Access Compliance Report

Public Rights-of-Way

(Pedestrian Signals)

Intersection ID: N/A	Main Street:	Cross Street: N/A	Location: N/A
ADA ID: 6A70D3324372	Signal Type: Two Push Buttons-Non APS	Overall Compliance: No	Severity Score: BTN 1:N/A BTN 2: N/A No BTN: N/A
Codes/Mitigation Info/Possible Solution		Field Measurements/Component Compliance

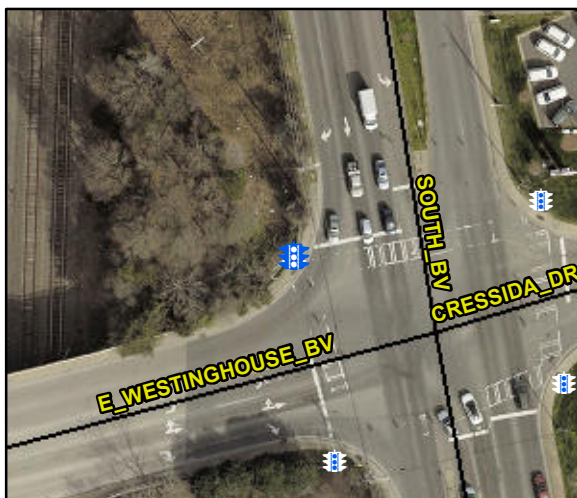
PROW/ADA: TMUTCD 4e.08, R404.3, R404.2, R406.2

Compliance	Description	Data	Compliance	Description	Data
	Button Count	Button2	N/A	Distant to Additional Button (in)	N/A
	Additional Button Present?	No		Additional Button ID	N/A
N/A	Signal Buttons Required?	N/A	N/A	Additional Ped Posts Required	N/A
	How Many Ped Street Xings?	2		Located In An Island/Median?	No
N/A	B 1 Sign Present?	Yes	N/A	B 2 Sign Present?	Yes
Yes	B 1 Sign Purpose?	Yes	Yes	B 2 Sign Purpose?	Yes
Yes	B 1 Sign Lettering & Contrast?	Yes	Yes	B 2 Sign Lettering & Contrast?	Yes
Yes	B 1 Parallel To XWalk?	Yes	Yes	B 2 Parallel To XWalk?	Yes
No	B 1 PAR to Button?	No	No	B 2 PAR to Button?	No
No	B 1 PAR to XWalk?	No	No	B 2 PAR to XWalk?	No
Yes	B 1 Clear Floor Space?	Yes	Yes	B 2 Clear Floor Space?	Yes
N/A	B 1 FWD Approach?	Yes	N/A	B 2 FWD Approach?	Yes
N/A	B 1 FWD Approach Constrained?	No	N/A	B 2 FWD Approach Constrained?	No
No	B 1 FWD Approach Reach (in)	5.0	No	B 2 FWD Approach Reach (in)	7.0
N/A	B 1 FWD Approach Width (in)	N/A	N/A	B 2 FWD Approach Width (in)	N/A

N/A	B 1 FWD Approach Obstruction?	Yes	N/A	B 2 FWD Approach Obstruction?	Yes
N/A	B 1 FWD Approach Obstruction Dist (in)	0.0	N/A	B 2 FWD Approach ObstructionDist (in)	0.0
N/A	B 1 PARA Approach?	Yes	N/A	B 2 PARA Approach?	Yes
N/A	B 1 PARA Approach Constrained?	No	N/A	B 2 PARA Approach Constrained?	No
Yes	B 1 PARA Approach Reach (in)	4.0	Yes	B 2 PARA Approach Reach (in)	4.0
N/A	B 1 PARA Approach Width (in)	N/A	N/A	B 2 PARA Approach Width (in)	N/A
N/A	B 1 PARA Approach Obstruction?	Yes	N/A	B 2 PARA Approach Obstruction?	Yes
N/A	B 1 PARA Approach Obstruction Dist (in)	0.0	N/A	B 2 PARA Approach ObstructionDist (in)	0.0
Yes	B 1 Clear Floor Space Slope (%)	0.9	Yes	B 2 Clear Floor Space Slope (%)	0.9
No	B 1 Clear Floor Space XSlope (%)	7.3	No	B 2 Clear Floor Space XSlope (%)	7.1
N/A	B 1 PAR Slope (%)	4.1	N/A	B 2 PAR Slope (%)	3.8
Yes	B 1 Height (in)	44.0	Yes	B 2 Height (in)	42.0
Yes	B 1 Pressure (#)	3.0	Yes	B 2 Pressure (#)	3.0

Yes	B 1 Clear Xing Direction?	ClearlyMarked	Yes	B 2 Clear Xing Direction?	ClearlyMarked
	B 1 Crossing Direction	To SE		B 2 Crossing Direction	To NE
Yes	B 1 DistanceTo XWalk (in)	0.0	Yes	B 2 DistanceTo XWalk (in)	18.0
No	B 1 DistanceTo Curb (in)	80.0	No	B 2 DistanceTo Curb (in)	80.0
Yes	B 1 Diameter (in)	2.0	Yes	B 2 Diameter (in)	2.0

Possible Solutions: Replace Signal Push Button With APS Button on New Post. Remove & Relocate Sign.
